20-139PDP – HEARTLAND BANK

Summary

This is a request for review and approval of a Preliminary Development Plan for exterior modifications and associated site improvements for an existing bank on a 0.82-acre site located in the Bridge Street District (BSD).

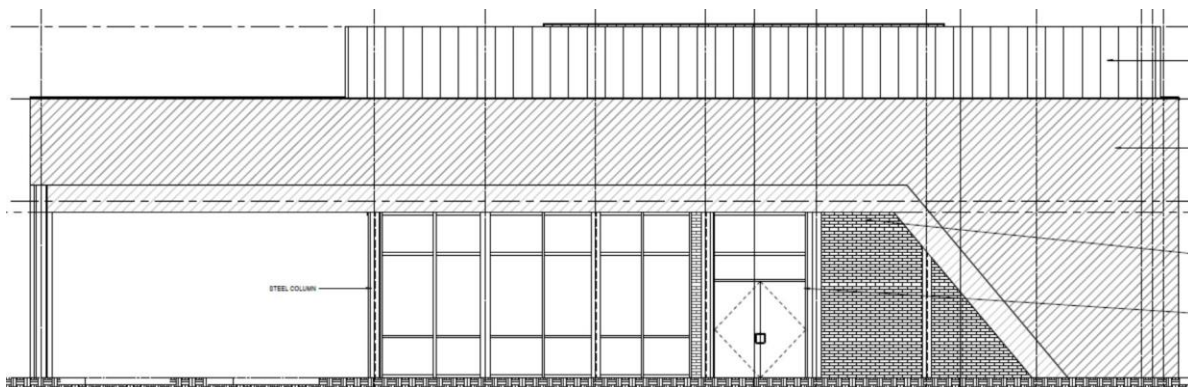
The applicant is proposing a modernization and remodel to the entire exterior of the existing structure. The renovation replaces the combination of flat and hipped roofs with a simplified flat roof system. The proposal includes the replacement of the existing overhang with a new overhang and screening system clad in a Trespa Meteon High-Pressure Compact Laminate (HPL) material in a contemporary wood finish. The existing white columns which support the overhang are proposed to be replaced with steel I-beams to complement the contemporary wood aesthetic.

Per the BSD Code, permitted primary materials include, but are not limited to, stone, manufactured stone, full-depth brick, and glass. Permitted secondary materials include fiber reinforced gypsum, wood siding, fiber cement siding, metal, and exterior architectural metal panels and cladding. Code also requires that each façade visible from a street or adjacent property be comprised of a minimum of 80-percent primary material. The applicant is not meeting this requirement on any façade, and is requesting a Waiver to this requirement.

The applicant is proposing that at least 59 percent of each façade be clad in a secondary material (metal panel) or Trespa Meteon material, which requires a Waiver. Per Code, high-quality synthetic materials may be approved as permitted primary or secondary

In addition to the new overhang and screening, the applicant is proposing to install a new aluminum storefront system which ultimately increases transparency from its current state. However, despite the increase in transparency, the proposal does not meet the minimum transparency requirements per Code, requiring a Waiver. Staff is supportive of a Waiver since the proposal increases transparency, bringing it closer to compliance with the BSD Code. The applicant should ensure that a minor calculation discrepancy for transparency is addressed prior to submitting for a Final Development Plan.

To allow for adequate screening of mechanicals and of the existing gabled roof, the applicant is also proposing a parapet taller than Code permits. Code permits parapets which are between two and six feet in height. The applicant is proposing a parapet which is approximately 12'-2" in height. This also requires approval of a Waiver, which Staff is supportive of since it allows for adequate screening and complements the overall contemporary aesthetic. The remaining brick will be painted dark gray.

- 1) Planning recommends **approval** of a Waiver to Zoning Code Section 153.062 — Building Types (E)(1) - Façade Materials.
- 2) Planning recommends **approval** of a Waiver to Zoning Code Section 153.062 — Building Types (O)(7)(d) – Transparency.
- 3) Planning recommends **approval** of a Waiver to Zoning Code Section 153.062 — Building Types (D)(1) – Parapet Height.

- 1) The applicant continue to work with Engineering on finalizing grading and drainage details with the Final Development Plan.
- 2) The applicant provide a parking plan to address the issue of excess parking on the site with the Final Development Plan.
- 3) The applicant correct the transparency calculations for the elevations prior to submitting for a Final Development Plan.
- 4) The applicant continue to work with Staff on selecting an appropriate exterior cladding material prior to the Final Development Plan.
